PCN/19/012/C+N

Product range: Interface connectors / Rundsteckverbinder inkl.

M12 PushPull

Title: M12 Power L-code PFT - External

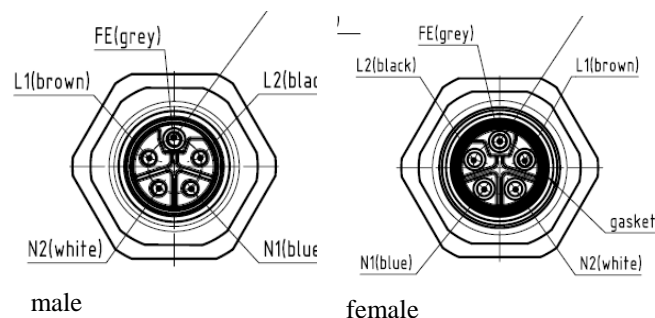
Change – New Pin assignment!

OLD

Potenzial	Contact-Number M12 L-code	Color coding
L1	Pin 1	brown
N1	Pin 2	blue
L2	Pin 3	black
N2	Pin 4	white
FE	Pin FE	grey

NEW

Potenzial	Contact-Number M12 L-code	Color coding
L1	Pin 1	brown
N1	Pin 3	blue
L2	Pin 4	black
N2	Pin 2	white
FE	Pin FE	grey

This change is in order to be compliance with the new PROFINET specification.
